ADA Curb Ramp New Construction Inspection Form (Perpendicular)

NW 309th Ave

24952.54

NW Timeric Dr

PERPENDICULAR RAMP (PR)

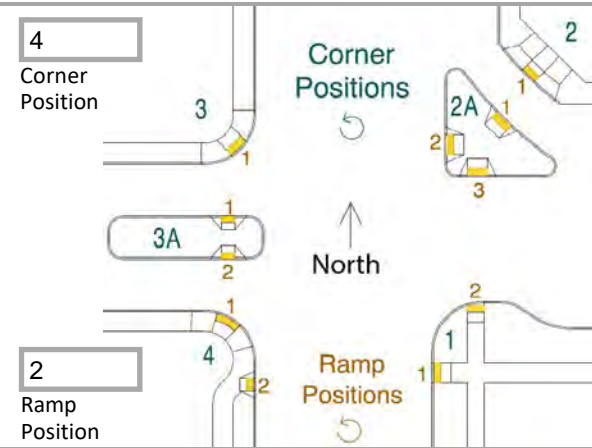
Failure, poor craftsmanship, warped turn space
